**NUMBER:** 23-014-07

Difficulty Releasing Soft Top Plastic Edge Retainers From B-Pillar Area Of Door Frame

2007                      (JK)                      Wrangler

**Fig. 1 SOFT TOP RETAINERS - RIGHT SIDE**

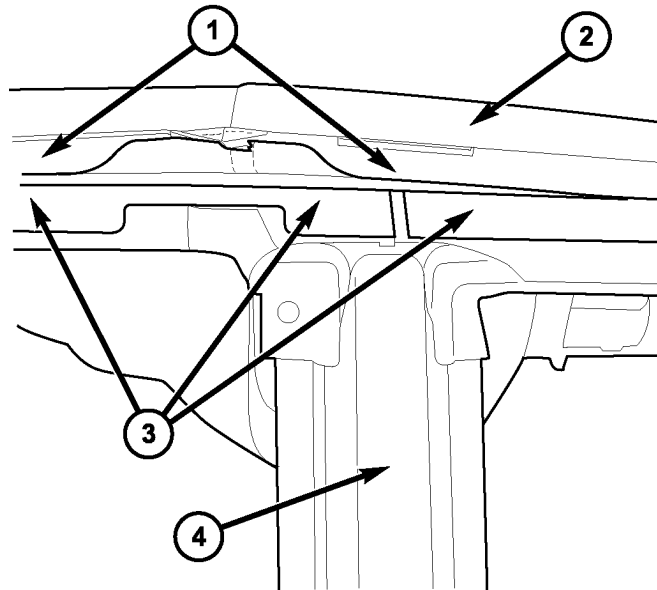
2. Locate the plastic edge retainers at the B-Pillar (Fig. 1).

- 1 - Soft Top Edge Retainers (Plastic) - Location Where Material Will Be Removed From Each Retainer
  - 2 - Four Door Soft Top (Right Side View)
  - 3 - Right Side Door Frame - Retainers Engage Door Frame Channels To Retain Edge Material Of Soft Top To Vehicle
  - 4 - "B" - Pillar (Four Door)
-

**Fig. 2 REPAIR TO FRONT RETAINER**

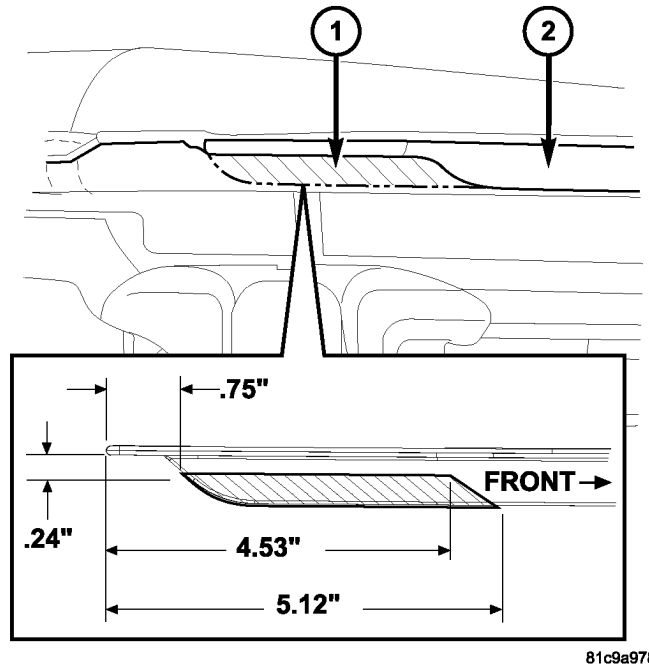
3. Remove the right side soft top edge retainers from the door frame.
4. Protect the soft top fabric from damage by isolating the plastic retainers from the soft top fabric. A clean fender cover can be used.
5. Using aviation style tin snips, remove plastic material from the front soft top edge retainer (Fig. 2).

- 1 - FRONT Soft Top Edge Retainer - Remove Plastic Material From This Area (Right Side View)
  - 2 - FRONT Soft Top Edge Retainer - Right Side View
-

**Fig. 3 REPAIR TO REAR RETAINER**

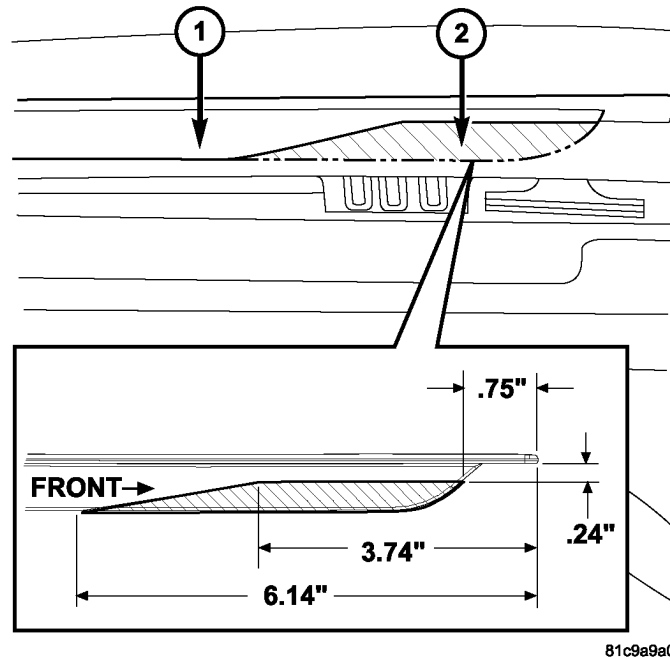
6. Remove plastic material from the rear soft top edge retainer (Fig. 3).

- 1 - REAR Soft Top Edge Retainer - Right Side View  
 2 - REAR Soft Top Edge Retainer - Remove Plastic Material From This Area (Right Side View)

- 
7. With a file, trim (dress off) the plastic retainers where the material was removed.  
 8. Install the plastic retainers to the door frame.  
 9. Verify that the retainers can be released easily at the B-Pillar.  
 10. Repeat steps 3 through 9 to the left side of the soft top plastic edge retainer.  
 11. Latch the soft top to the windshield header.
